# United States Patent and Trademark Office

APPLICATION NO.	FILING DATE	FIRST NAMED INVENTOR	ATTORNEY DOCKET NO.	CONFIRMATION NO
10/718,514	11/24/2003	Kenneth Gordon Walker	W245 0004	1974
720	7590 02/07/2006		EXAMINER	
OYEN, WIGGS, GREEN & MUTALA LLP			BOGART, MICHAEL G	
480 - THE STATION 601 WEST CORDOVA STREET VANCOUVER, BC V6B 1G1 CANADA			ART UNIT	PAPER NUMBER
			3761	
			DATE MAILED: 02/07/2006

#### **DETAILED ACTION**

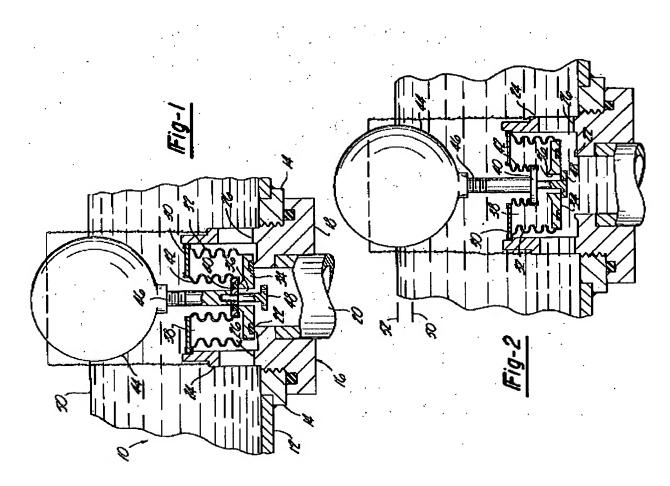
Regarding claims 2 and 3, Matta teaches a check valve (16) for a canister (12) adapted to receive fluids, said canister having a vacuum port (36) for application of vacuum to said canister (12) for inducing a flow of fluids into said canister (12), said check valve (16) being operably coupled to said vacuum port (36) for stopping said application of vacuum to said canister (12) when said fluids in said canister (20) reach a pre-determined level, said check valve (16) comprising:

- (a) a floatball (44);
- (b) a needle valve (40, 46, 48);
- (c) a needle valve guide (34) for slidably retaining said needle valve (40, 46, 48), said needle valve (40, 46, 48) being positioned to be engaged by said floatball (44) to close said vacuum port (36)(see figures 1 and 2, below).

It is noted that the figures appear to show a cage surrounding the floatball (44), however the reference is silent as to what that structure is.

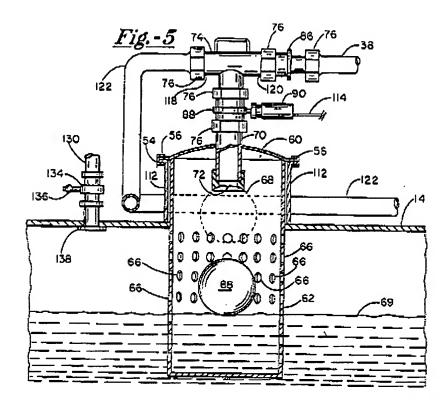
Engle teaches a floatball valve (68) in a fluid container (14) that is surrounded by a cage (62) to keep it aligned (see fig. 5, below).

At the time of the invention, it would have been obvious for one of ordinary skill in the art to add the cage of Engel to the floatball valve of Matta in order to keep it aligned with the port.
